**DOCUMENT 00 90 00**  
**ADDENDUM**

**ADDENDUM No.:** 2

**DATE:** April 1, 2025

**RE:** WESTERN TECHNICAL COLLEGE  
STUDENT SUCCESS CENTER RENOVATION  
400 N. 7TH STREET  
LA CROSSE, WISCONSIN 54601

**ED02**

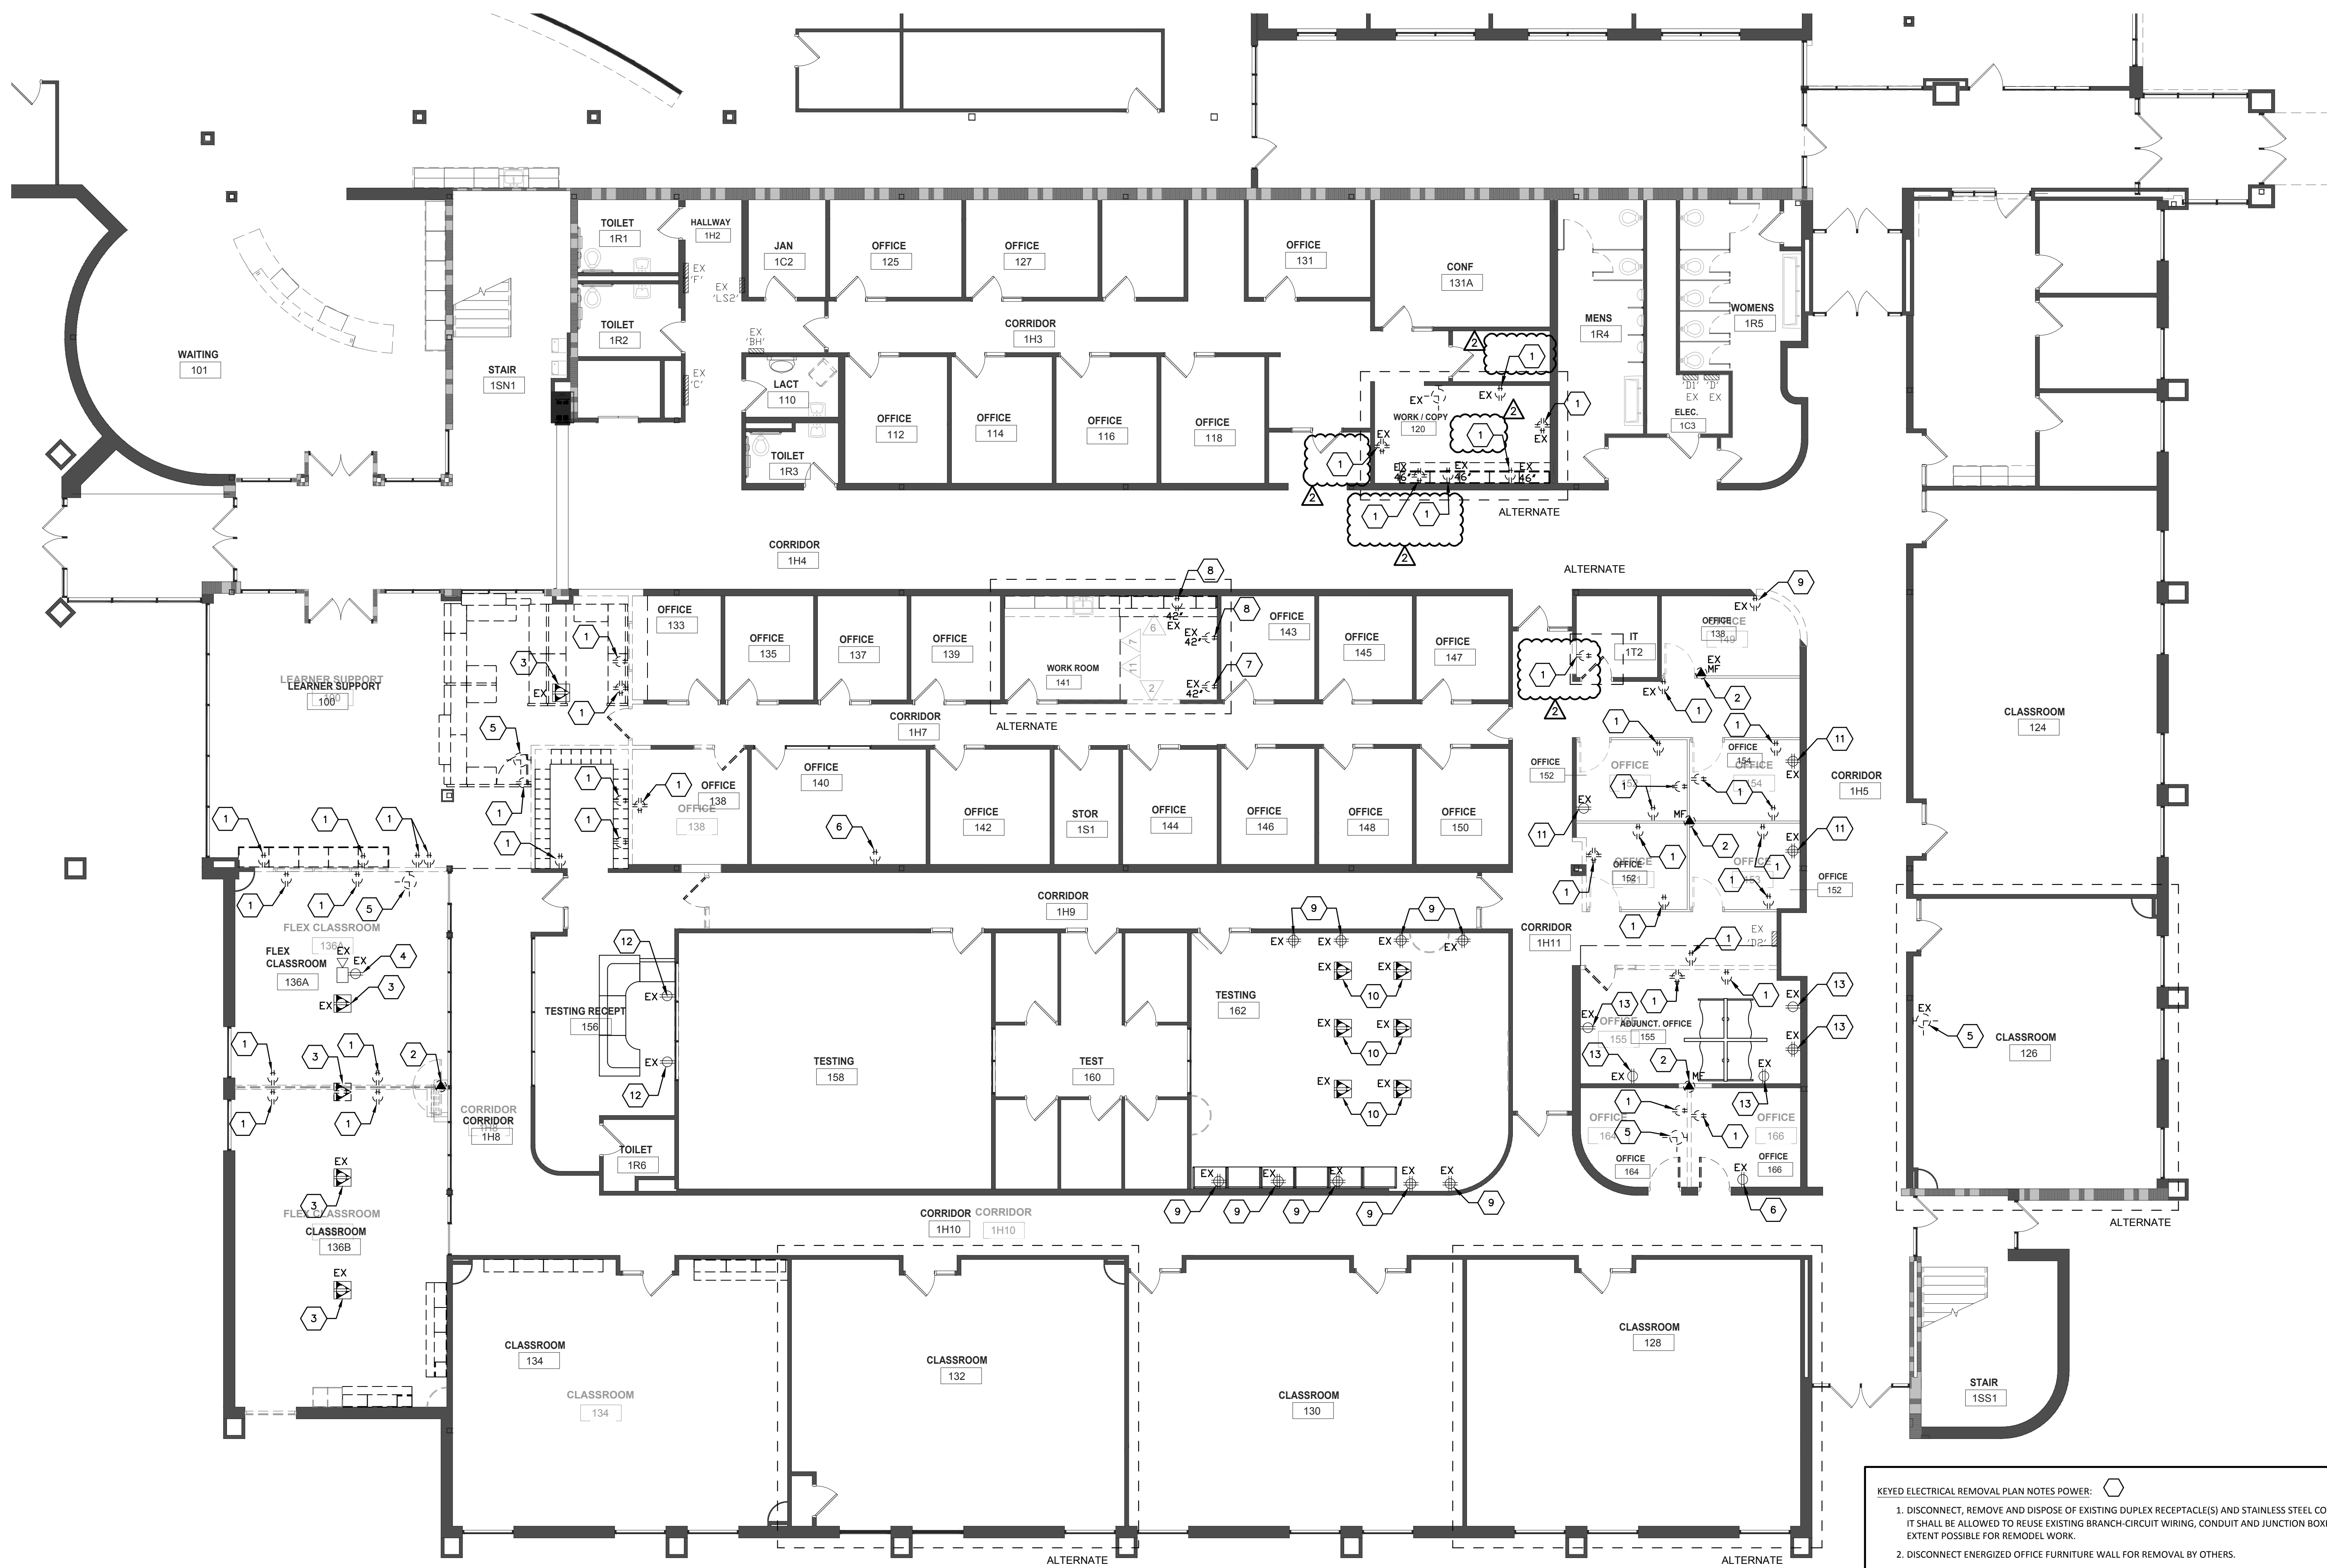
10. Sheet ED02 SECOND FLOOR LIGHTING DEMOLITION PLAN 30"x42"
  - a. See the revised sheet included in this addendum. Disregard the previous version.
  - b. Refer to Computer Room #222;

- i. Revised work in this room, refer to clouded change labeled addendum 2.
11. Sheet ED03 FIRST FLOOR POWER DEMOLITION PLAN 30"x42"
  - a. See the revised sheet included in this addendum. Disregard the previous version.

# 1 FIRST FLOOR POWER DEMOLITION PLAN

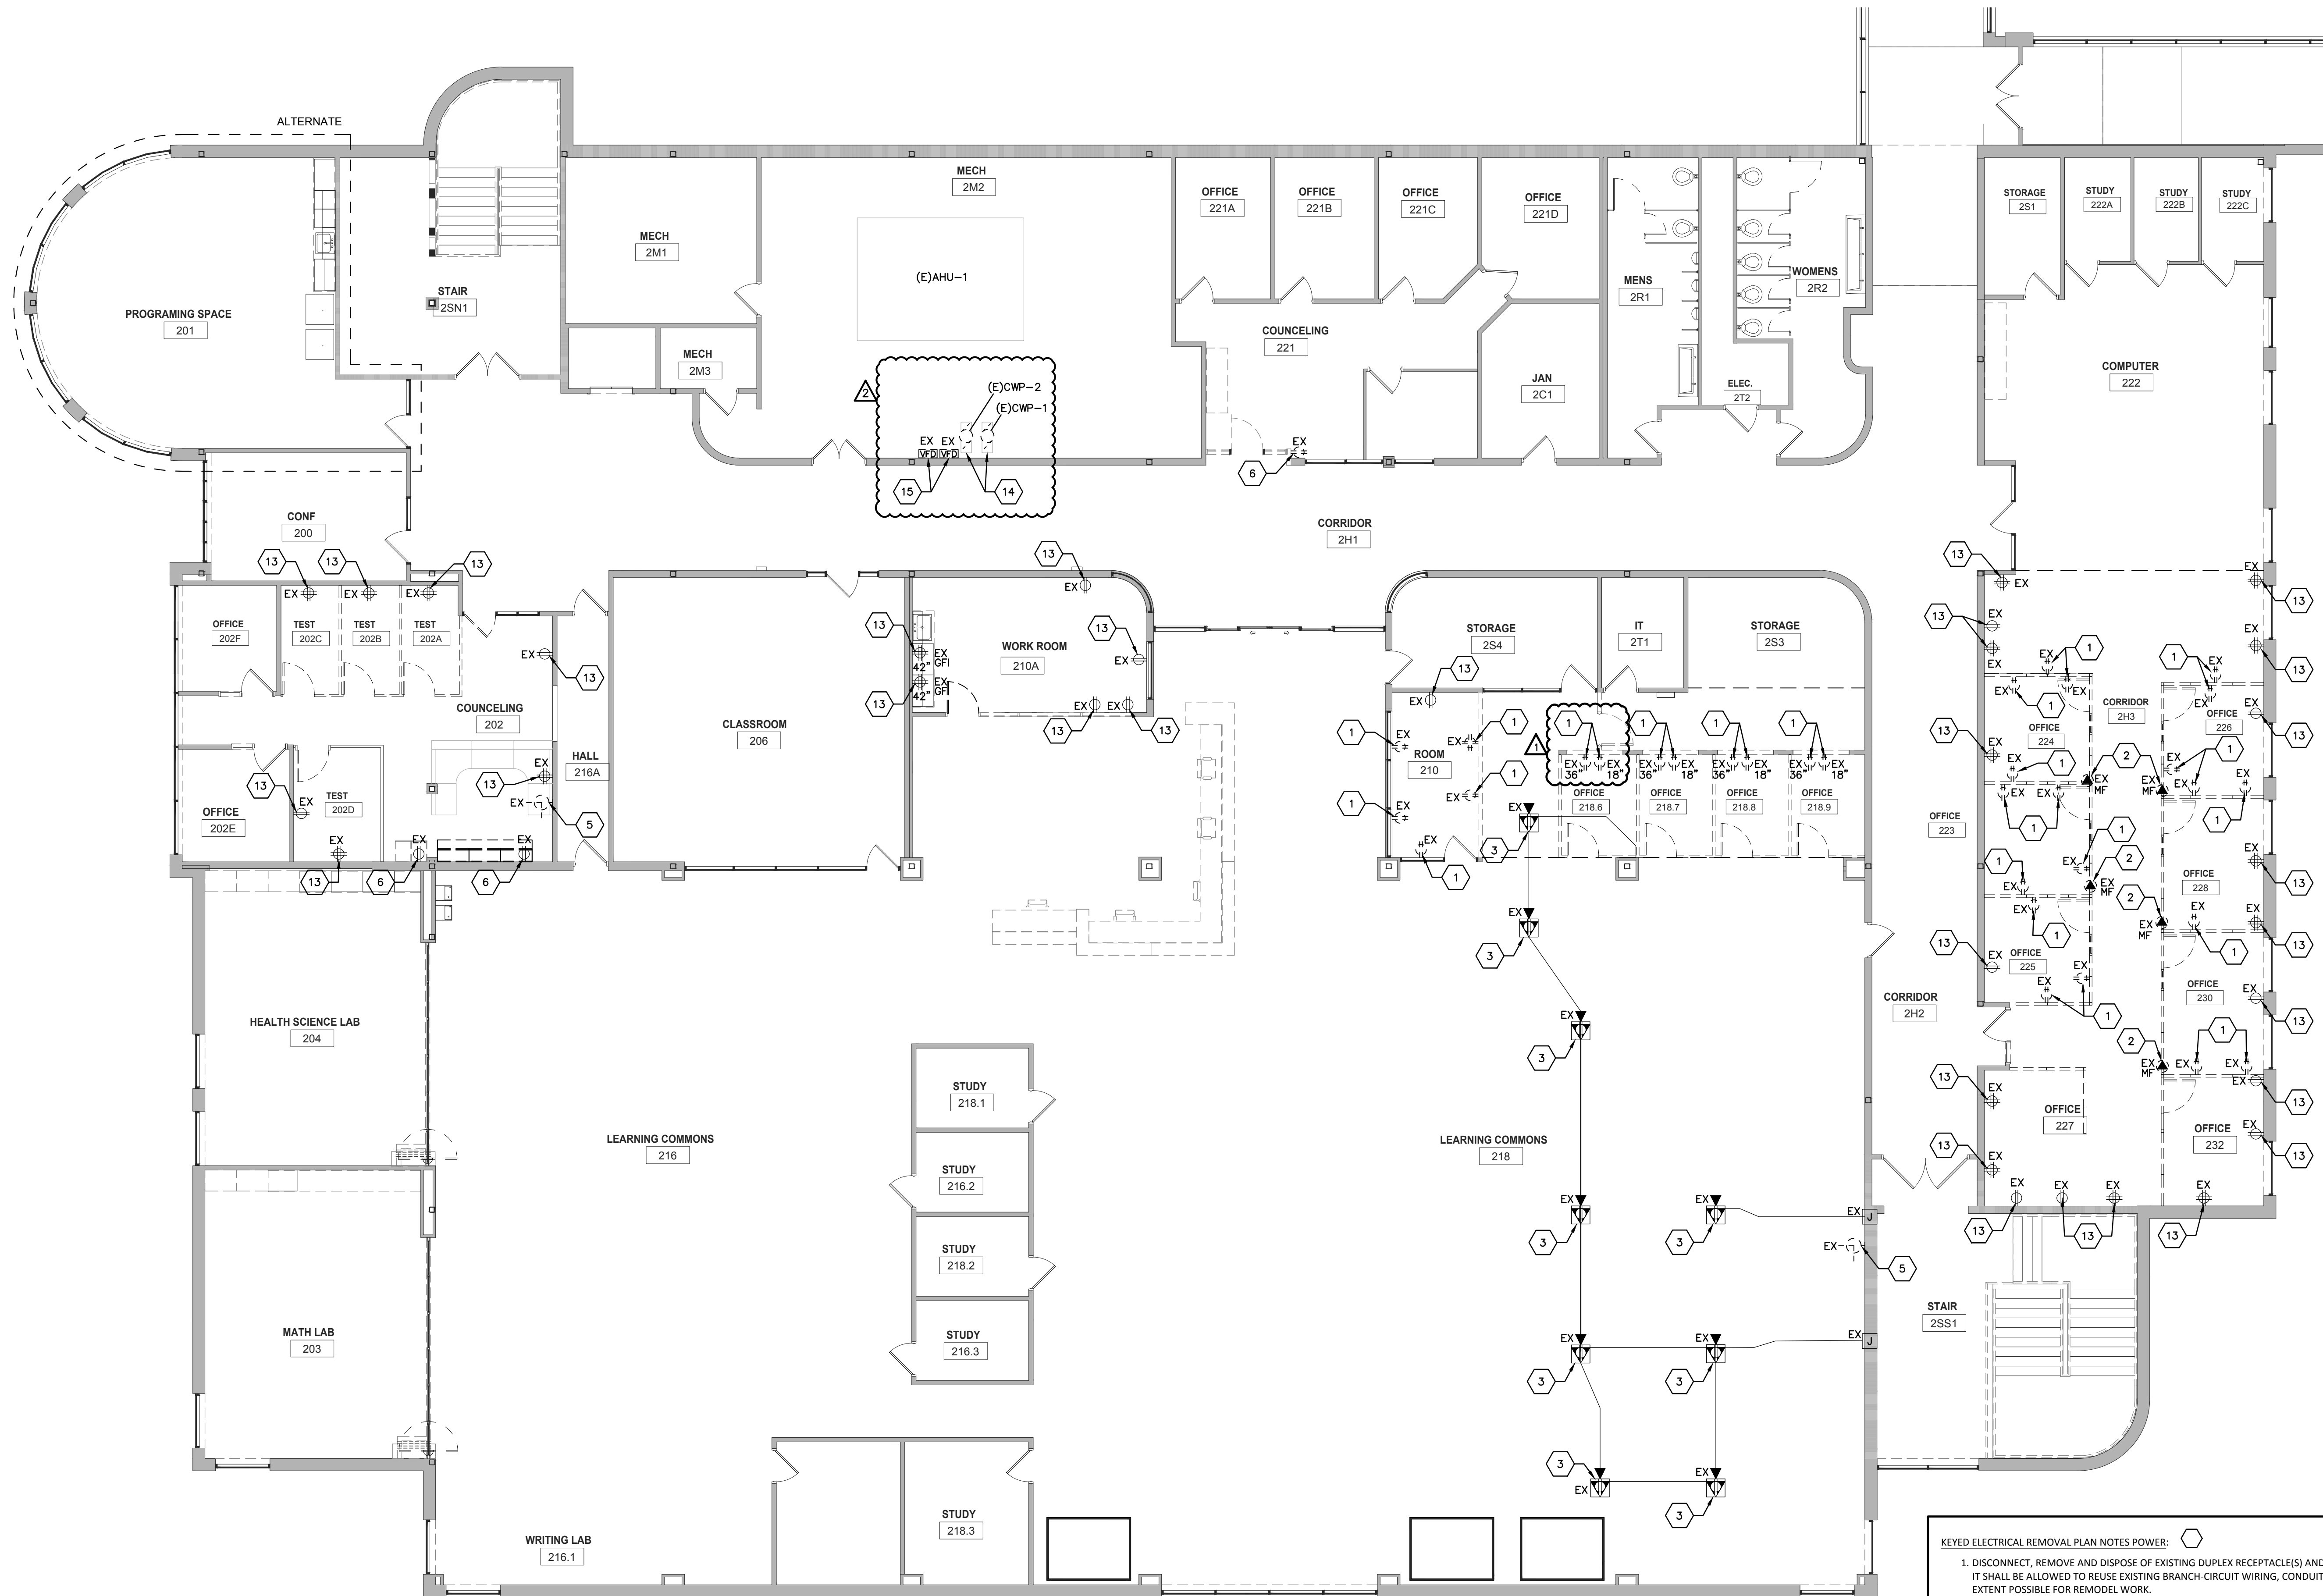
- b. Refer to Work/ Copy #120;
    - i. Revised work in this room, refer to clouded change labeled addendum 2.
  - c. Refer to IT Room #1T2;
    - i. Delete duplex receptacle, please note a new door to be installed in this location. Refer to clouded change labeled addendum 2.
